# Product Change Notification

## 108422 - 01

**Change Notification #:** 108422 - 01  
**Change Title:** Intel® Carrier Grade Server TIGW1U,PCN 108422-01, Product Discontinuance, Product Code Discontinuance and Replacement Announcement, Reason for Revision: Correct BMC and FRUSDR versions  
**Date of Publication:** May 23, 2008

Figure 3. Change to Captive Screw on PCI riser assembly

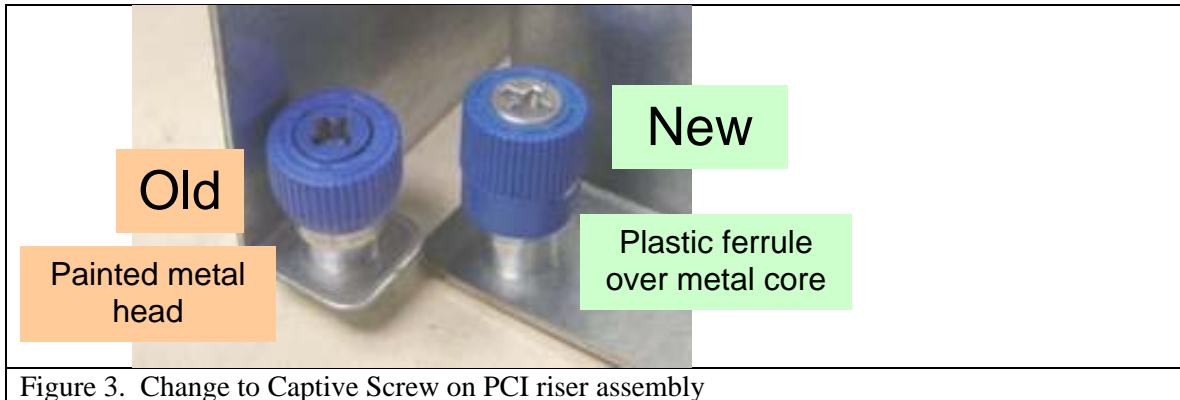
3. Changed Captive Screw type on PCI riser, as shown in Figure 3.

Figure 4. Added clip to drive bay

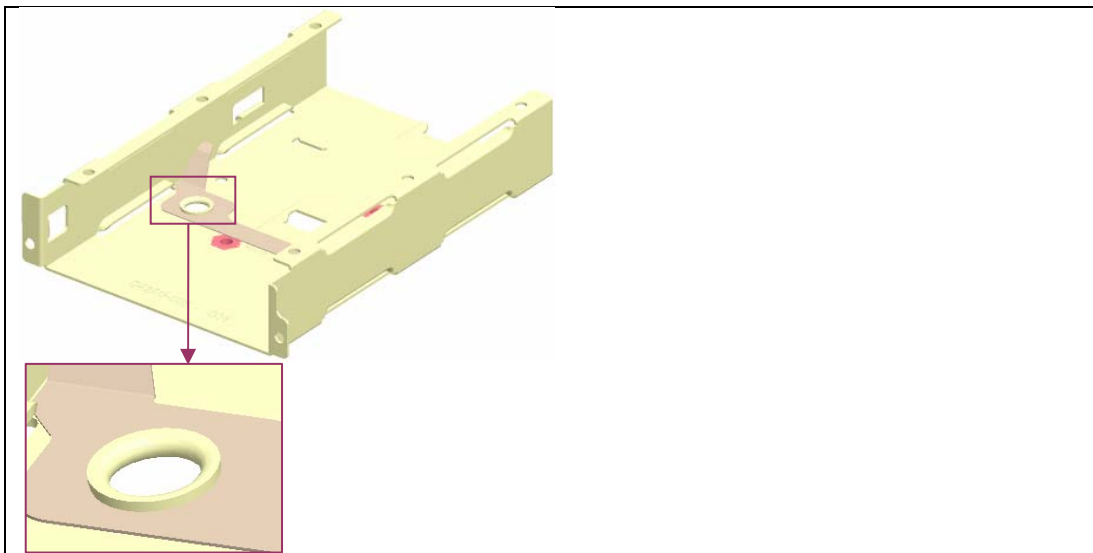
4. Changed insulator material between boards and chassis, and on PCI support bracket from Formex\* to Statex\*. Added additional adhesive to improve adhesion at higher temperature.
5. Added clips to the drive bay to reduce transmission of rotational vibration, as shown in Figure 4.

Figure 5. Changed Fan Bracket Sheet Metal.

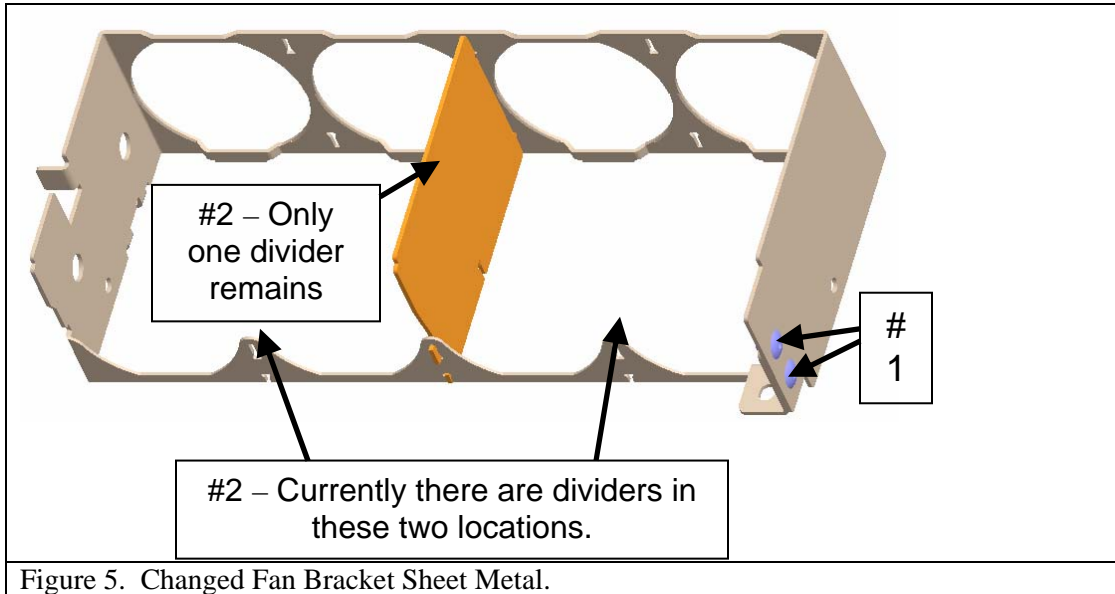
6. Changed CPU Fan Bracket sheet metal to improve RV (Rotational Vibration) performance.
  - a. Re-located rivet holes on outside surface to eliminate the gap/twist problem.
  - b. Deleted two bay dividers (#2), leaving one divider for better RV performance.
